- 6. Terra Firma Subdivision Johnson Addition  
KPB File 2022-171**

ITEM 6 - TERRA FIRMA SUBDIVISION JOHNSON ADDITION

<b>KPB File No.</b>	2022-171
<b>Plat Committee Meeting:</b>	December 12, 2022
<b>Applicant / Owner:</b>	Rosemary Johnson of Anchor Point, AK
<b>Surveyor:</b>	Jason Schollenberg / Peninsula Surveying, LLC
<b>General Location:</b>	Sterling Highway, Sluice Way, Glover Street, Anchor Point

STAFF REPORT

KPB File # 2022-171  
S11 T04S R15W  
Anchor Point

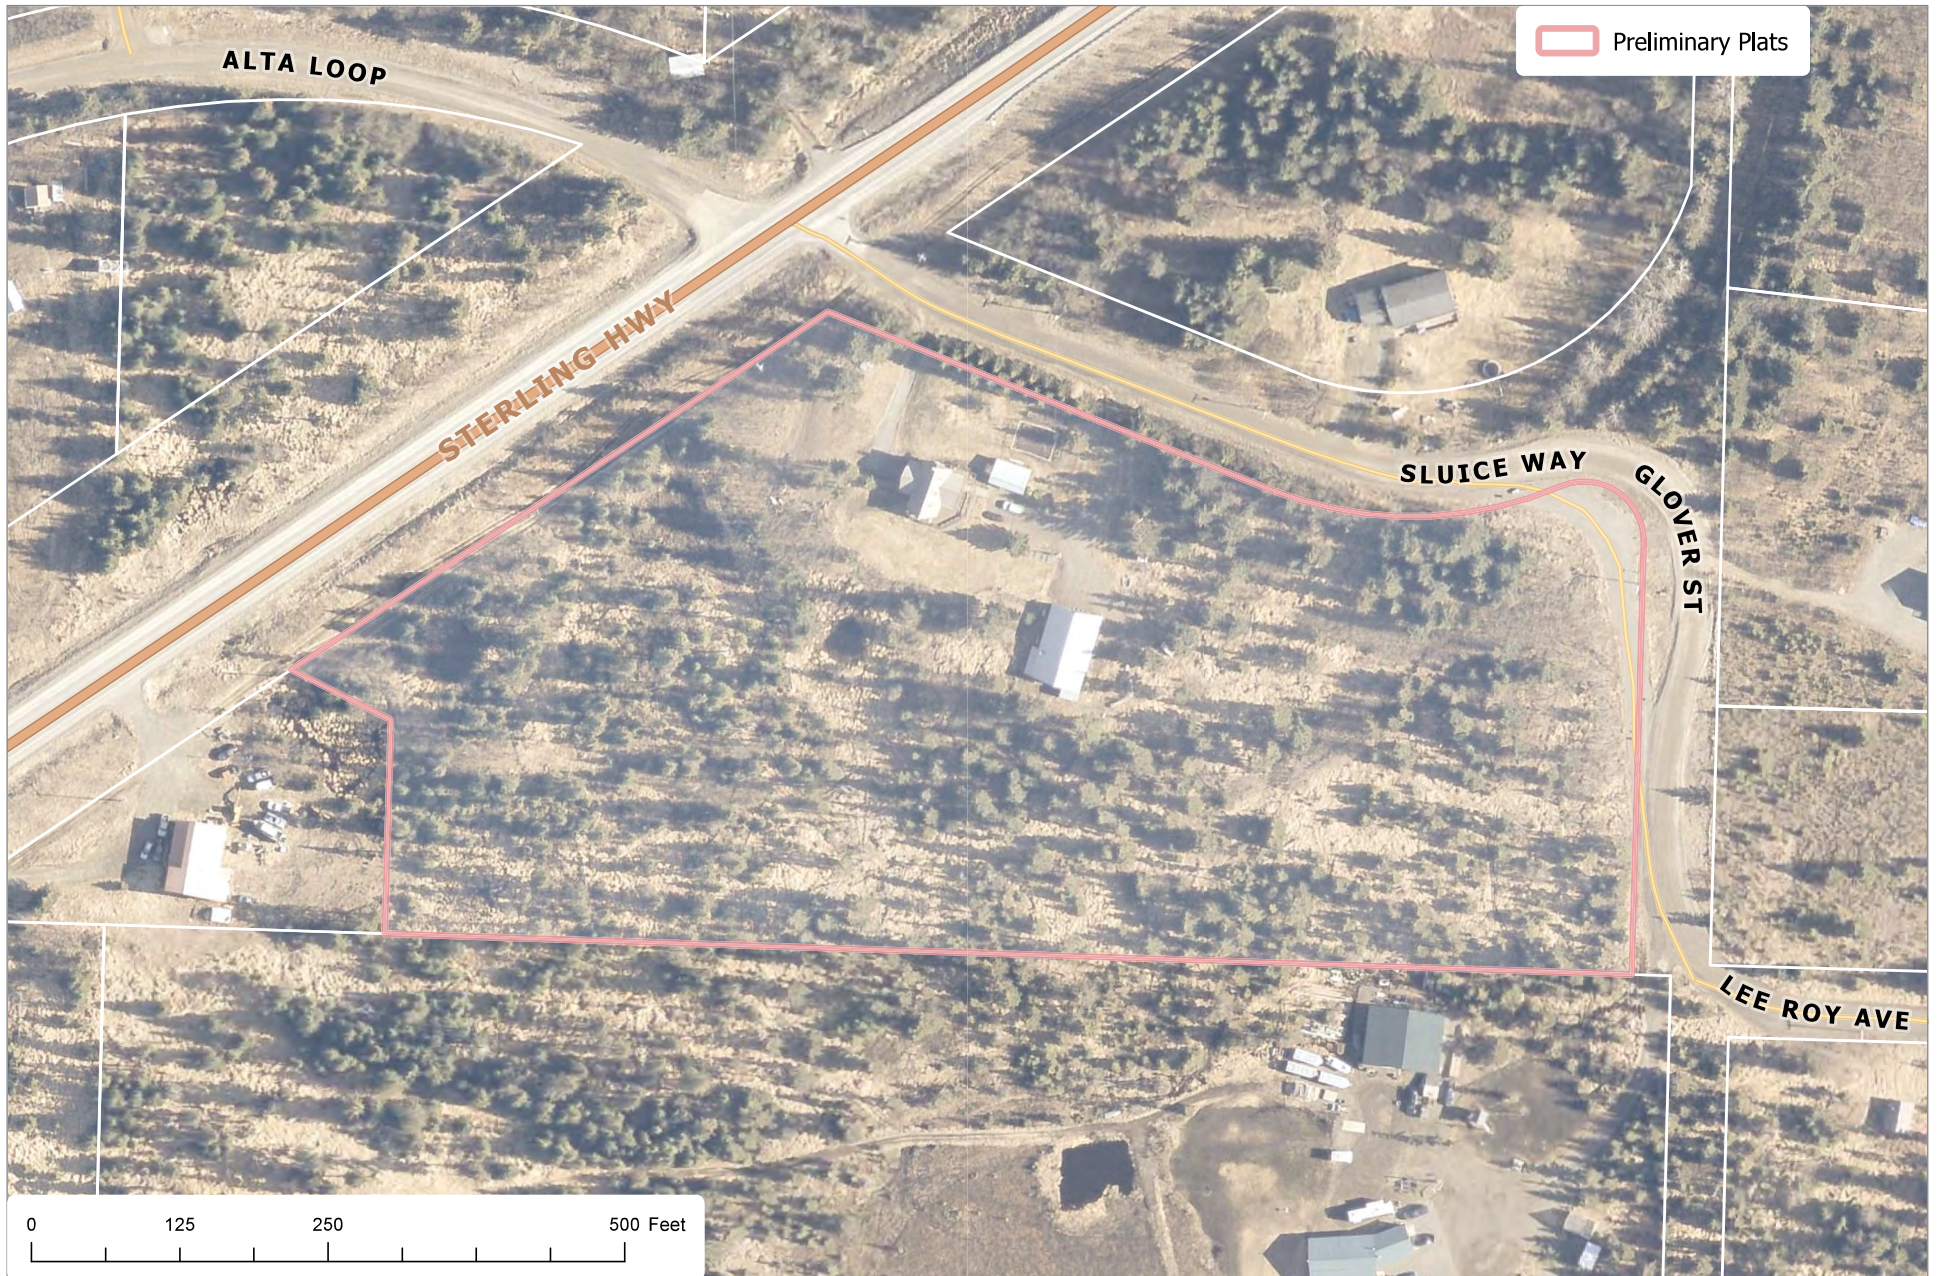
**Location and Legal Access (existing and proposed):** The proposed plat is located on Sluice Way between Sterling Highway and Glover Street. Sterling Highway is a state maintained right-of-way that is 232 feet wide in this area. Sluice Way is located near Sterling Highway mile marker 151.5. Sluice Way is 100 feet wide and was a former portion of state maintained Old Sterling Highway. The name of the right-of-way was changed to Sluice Way by Resolution SN 2010-01. Jurisdiction of the right-of-way was given from the state to the borough and is borough maintained. Glover Street is dedicated as a 66 foot wide right-of-way atop 66 foot wide section line easements. The portion adjacent to the subdivision is constructed and borough maintained. Glover Street is only constructed to Lee Roy Avenue where the roadway turns and continues. South of the subdivision Glover Street has only received a 50 foot dedication for the eastern portion but a 33 foot section line easement provides additional width.

Existing access is developed from Sluice Way and will continue to provide access to proposed Lot 2. Lot 3 will have access from Sluice Way and Glover Street and Lot 4 will have access from Glover Street. Lot 1 is proposed to have access from the Sterling Highway. Access to the highway must be permitted by Alaska DOT. A plat note will be required that states access must be approved by the State of Alaska.

It appears that a portion of constructed travelway is within proposed Lot 3 that appears to be the portion of the access easement that was used prior to dedications. Imagery from 1996 shows this portion constructed as the dedication did not occur until 2000. Current imagery shows the new constructed road within the dedication and what appears to be barriers to limit access through Lot 3. Staff requests verification from the surveyor when the field work is completed to let us know if that portion is still in use.

**Staff recommends** source for highway information should be cited either by label or plat note.

There are improvements located on the subdivision that will be located on Lot 2 of the proposed subdivision. There does not appear to be any encroachment issues but the surveyor will need to confirm the back structure will not encroach the new property line.

**Utility Easements** Terra Firma Subdivision, Plat HM 2000-66, granted 10 foot utility easements adjoining dedicated rights-of-way that increased to 20 feet within 5 feet of side lot lines. The 10 foot easement is depicted and labeled per HM 2000-66. **Staff recommends** the label include the width.

Per plat note 1 this plat will also be adding to the existing easement by granting 20 feet within 5 feet of the new side lot lines. **Staff recommends** the depiction be updated to show the 20 foot along all side lot lines.

A 20-foot utility easement centered on the existing power line located on the east side of the subdivision coming from the parent plat. HEA has requested the source of the easement be stated. **Staff recommends** that the easement be labeled “as granted on plat HM 2000-66”.

**Staff recommendation:** Provide a depiction of the centerline of the Sterling Highway, if less than 100 feet to centerline then include the full width of the Sterling Highway in the depiction.

**Staff recommendation:** There is an existing structure that looks like it may be close to the new lot line. This will require verification and resolution if found to cross the new lot line.

Correct plat note 5 to “...et al...”
